ADDENDUM NO. 2

DATE: September 18, 2026

RE: CONGO RD./SHENANDOAH RD. ROUNDABOUT (BENTON) (S), F.A.P. STPU-9035(26), ARDOT JOB NO. 061717 – 21-5829

SUMMARY OF QUANTITIES AND REVISIONS

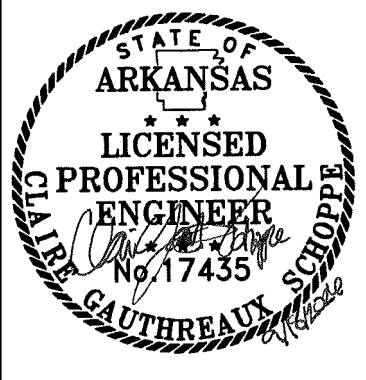
1. Sheet 2, Index of Sheet, Std. Drawings, Gov. Specs, & General Notes:
 - Replace with attached revised Sheet 2, Index of Sheet, Std. Drawings, Gov. Specs, & General Notes.
2. Sheet 20, Summary of Quantities and Revisions:
 - Replace with attached revised Sheet 20 Summary of Quantities and Revisions
